REQUEST

SUMMARY OF PETITION

The petition proposes to allow a townhome community on acreage next to S. Bruns Avenue Elementary, north of Wesley Heights Way and west of West Trade Street.

STAFF RECOMMENDATION

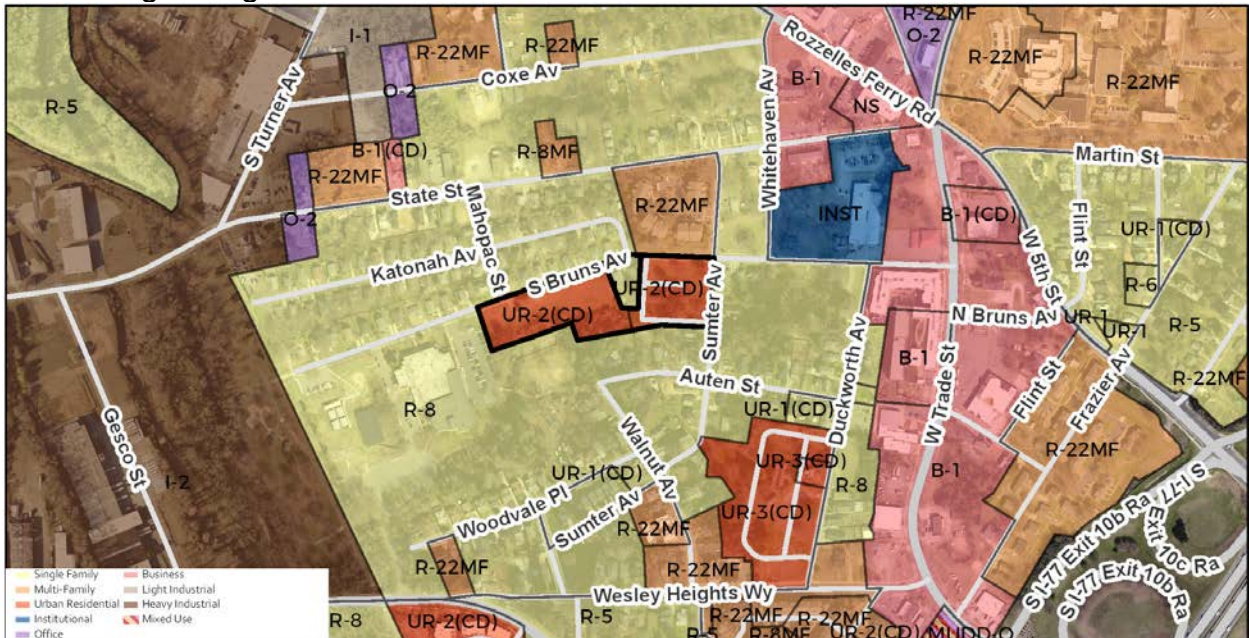
3. ~~The length of the buildings fronting S. Bruns Avenue and across from the existing smaller single family homes remains too long and are out of context. Petitioner should reduce to a series of three-unit buildings with the possibility of one or two four-unit buildings interspersed. Amend Note 4.e to reflect the specific request above.~~ Addressed. The Petitioner has reduced the number of units in the buildings fronting S. Bruns Avenue to a series of alternating 3-unit and 4-unit buildings and has updated Note 4.e accordingly.

4. ~~Petitioner should commit to some improved urban open space on the site plan.~~ Addressed. The Petitioner has committed to the urban open space area as shown on the site plan adjacent to the southern property boundary. The Petitioner commits to provide a singular type or mix of urban open space use(s).

5. ~~Remove Architectural Standards Note 4.j from the site plan.~~ Not addressed. The Petitioner would like Note 4.j (or a similar alternative) to remain on the site plan at this time due to the pending Text Amendment that may change the private open space requirement in the requested zoning district. The Petitioner intends to comply with any and all open space requirements of the Ordinance that are in place at the time of permitting.
